## Remote Battery Disconnect Switch Module Relocation

### RVXX1301, Remote Battery Disconnect Switch Module Relocation

(April 2013)

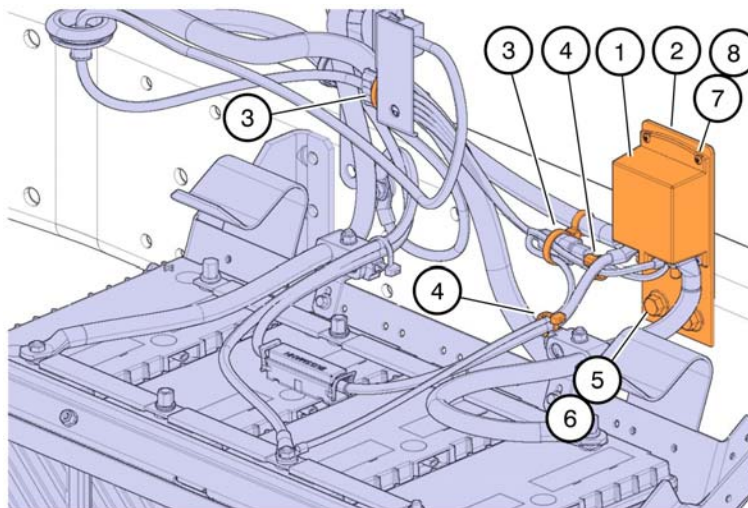
Volvo Trucks North America, has decided that a defect relating to motor vehicle safety may exist in certain Volvo VN vehicles manufactured between April 18, 2011 and March 14, 2013.

The remote battery disconnect switch module has been relocated to prevent an electrical shortage and fire.
